## **HEDDERMAN ENGINEERING, INC.**

REF: CONDITION OF PROPERTY SURVEY

At your request, a visual survey was made of the structural components of the house located at Houston, Texas, by Tim Hedderman.

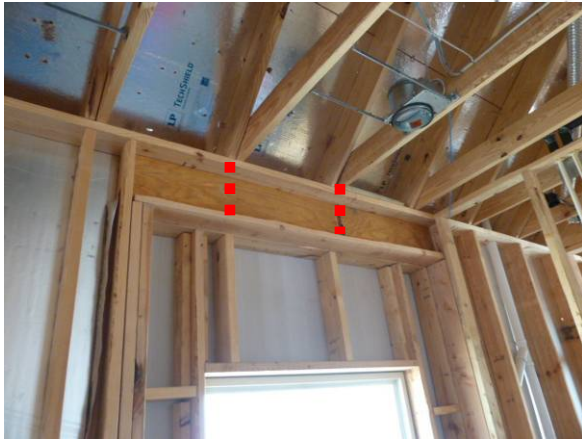
4. One of the wall studs was broken, and needs to be replaced, at the upstairs game room.

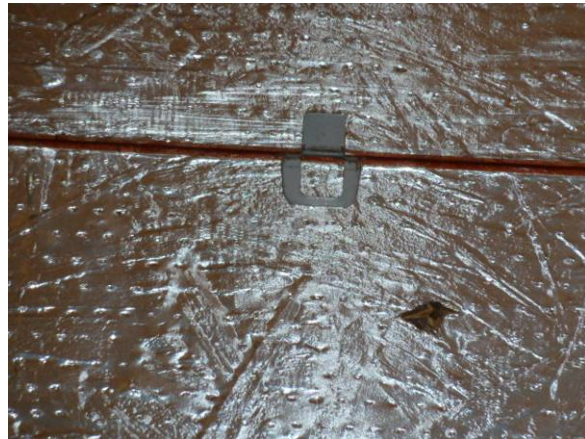
We observed a damaged shingle on the front elevation of the roof, and the damaged shingle needs to be replaced before it causes a roof leak.

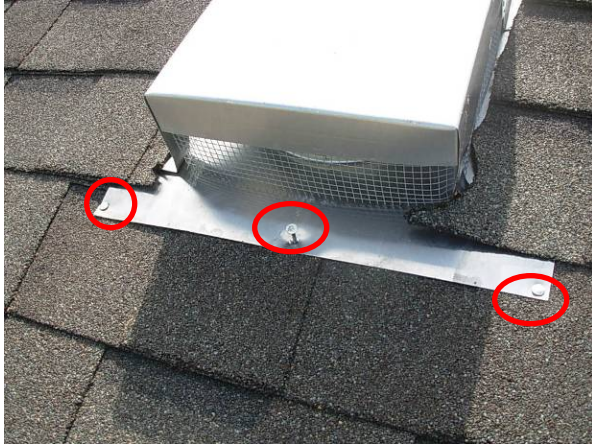
We observed that the nails used to secure the shingles to the roof deck were penetrating the roof deck, and were visible from the attic. This shows that the roofers used nails rather than staples, and that the nails were a proper length.

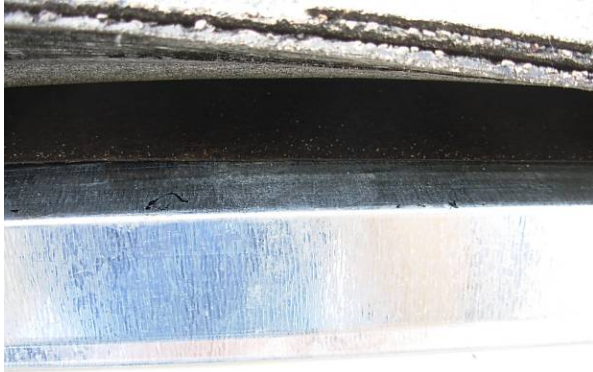
We observed a valley at the front part of the roof that narrows down, and will have a tendency to trap leaves and other debris. The area needs to be maintained to prevent a build up of debris. The area was flashed with metal flashing, which will help to prevent leaks in the area.

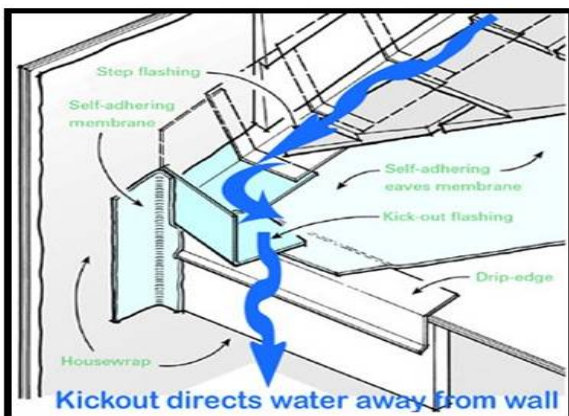
We lifted the edge of the shingles to verify that the tar paper underlayment was properly lapped on top of the drip edge flashing, and it was. No repairs are needed.

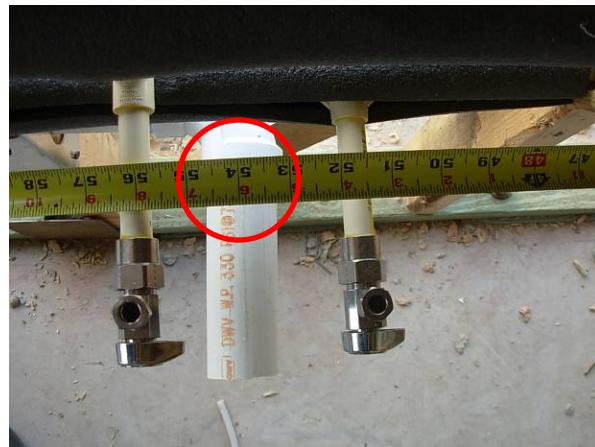
No electrical outlets have been provided at the kitchen island for the dishwasher and disposal.

## ELEVATION READINGS

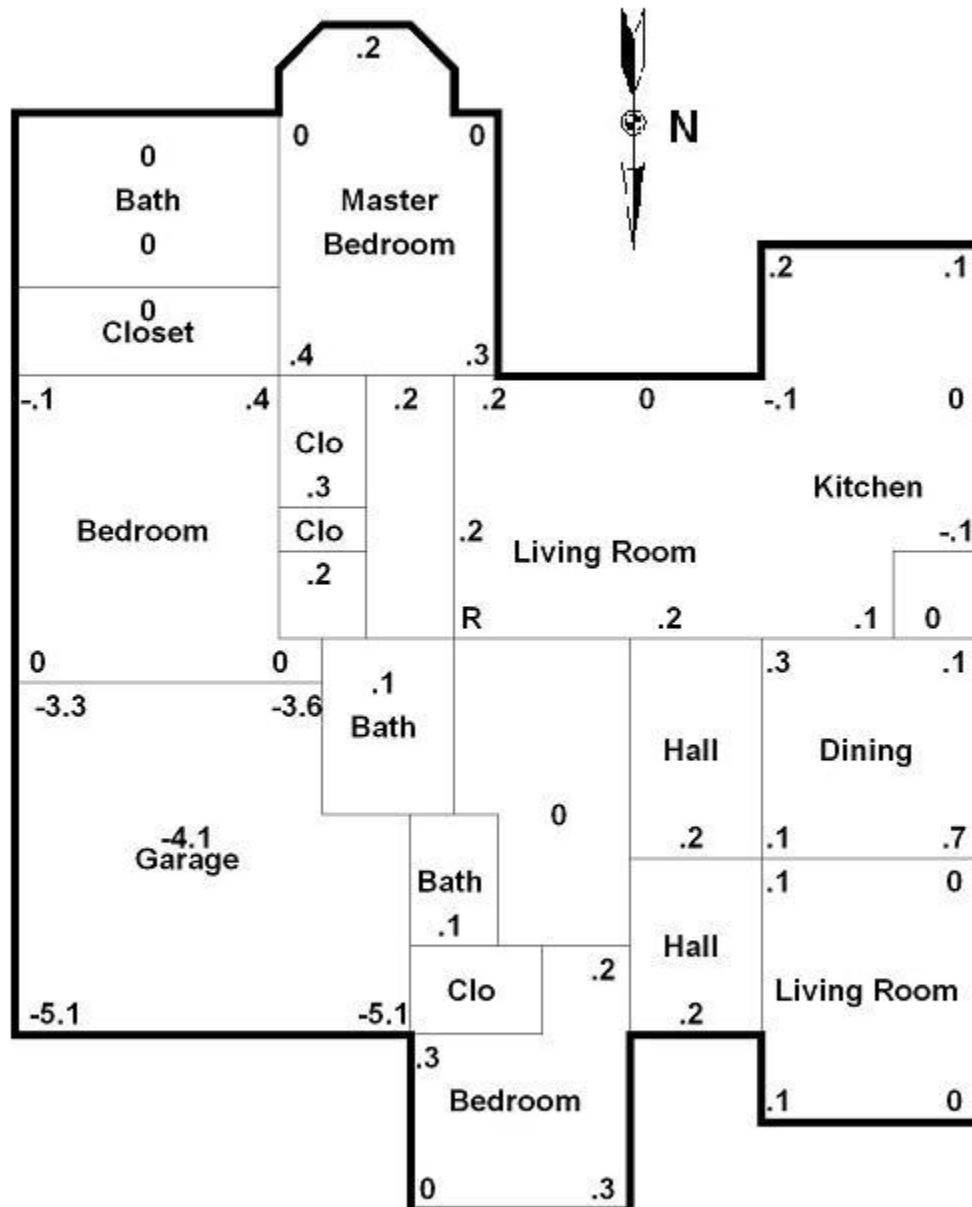
Normally horizontal surfaces, such as floors, door tops, counters, window sills, etc., were observed to be acceptably level throughout the house. The floors were checked with an electronic level, and the difference in elevation between the high point and low point was 0.8 inch. The high point was located at the west side of the house at the dining room, and the low point was located on the east side of the house at the center bedroom.

See our field sketch showing the elevation readings at the end of this report. Note that the "R" on the sketch is our randomly chosen starting reference point, where the elevation is 0, and all other elevation readings are taken relative to the reference point, and are measured in inches to the nearest 1/10 inch. Note also that elevation readings taken at the garage area are relatively large numbers relative to the reference point due to the step down into the garage area.
